U. S. NUCLEAR REGULATORY COMMISSION
REVIEW OF IDAHO NUCLEAR TECHNOLOGY AND ENGINEERING CENTER
DRAFT WASTE-INCIDENTAL-TO-REPROCESSING DETERMINATION FOR
TANK FARM FACILITY RESIDUALS

Figure 4. Illustration of the two-dimensional modeling slice used in PORFLOW

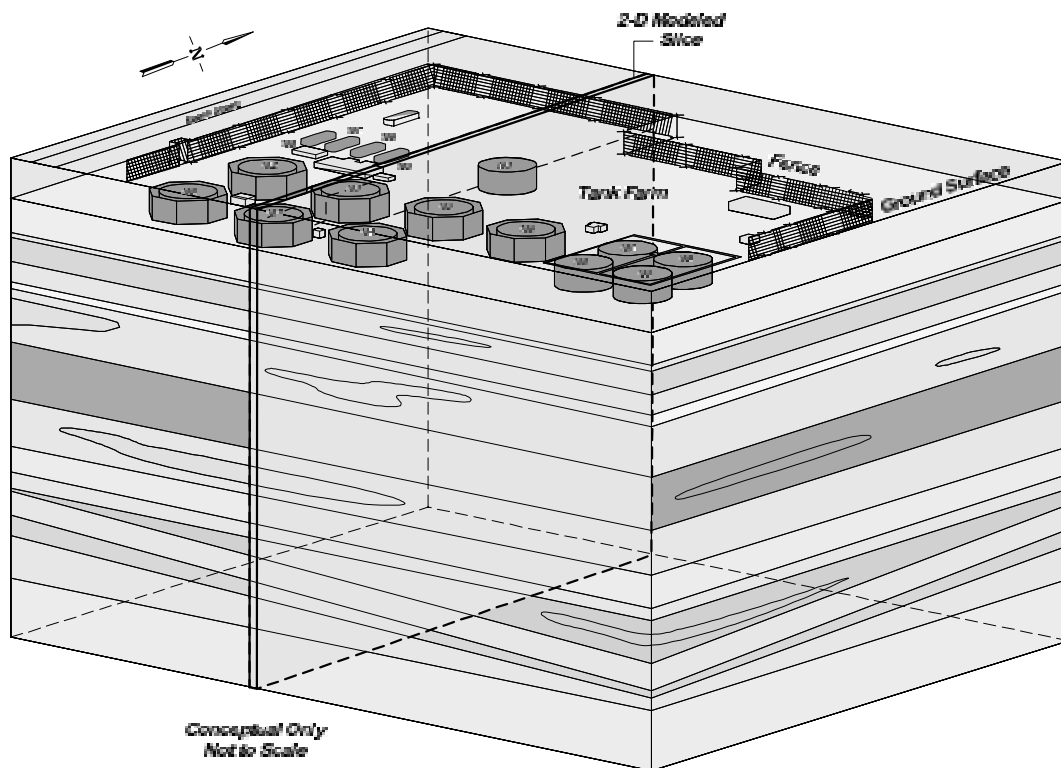
The interpretation of the results of flow and transport models for a site-specific application can be difficult when generic information is heavily relied on. Sorption coefficients used in transport modeling through the aquifer appear to have been appropriately chosen, considering the large degree of uncertainty in the absence of site-specific data. In particular, the retardation behavior of fractured basalts at the site is not well understood. Distribution coefficients can vary widely from site to site as a result of varying mineral composition and differing geochemical environments. For example, in one compendium study, the distribution coefficient for strontium ranged from 0.05 to 190 mL/g in sand; 0.01 to 300 mL/g in loam; and 3.6 to 32000 mL/g in clay [18]. DOE-ID typically assigned the minimum observed values to the distribution coefficients for interbed porous material [3]. Because this is likely to be conservative compared to the actual amount of geologic sorption, it is a reasonable approach to manage distribution coefficient uncertainty. The main exception to this approach was strontium, which used site-specific values generated from observations of radionuclide migration [35]. The use of site-specific information is preferable, as long as uncertainty associated with the development of the information is recognized and accounted for. For example, as discussed earlier, the infiltration rate at the site is uncertain. The development of strontium distribution coefficients of 12 to 24 mL/g could have been conditional on the particular infiltration rate that was used in the study.

The overall modeling approach appears to be a reasonable attempt to manage uncertain hydrologic and geologic information. It appears, in general, that DOE-ID appropriately assessed the TFF transport system through use of conservative assumptions. These conservative assumptions help to simplify the transport model as well as add confidence in the output. Conceptual model uncertainty can, in some cases, significantly impact the risk when transport is through a fractured, unsaturated hydrologic system. Confidence is gained with the DOE-ID approach as a result of the comparisons of the model predictions for tritium movement with the observations [36].
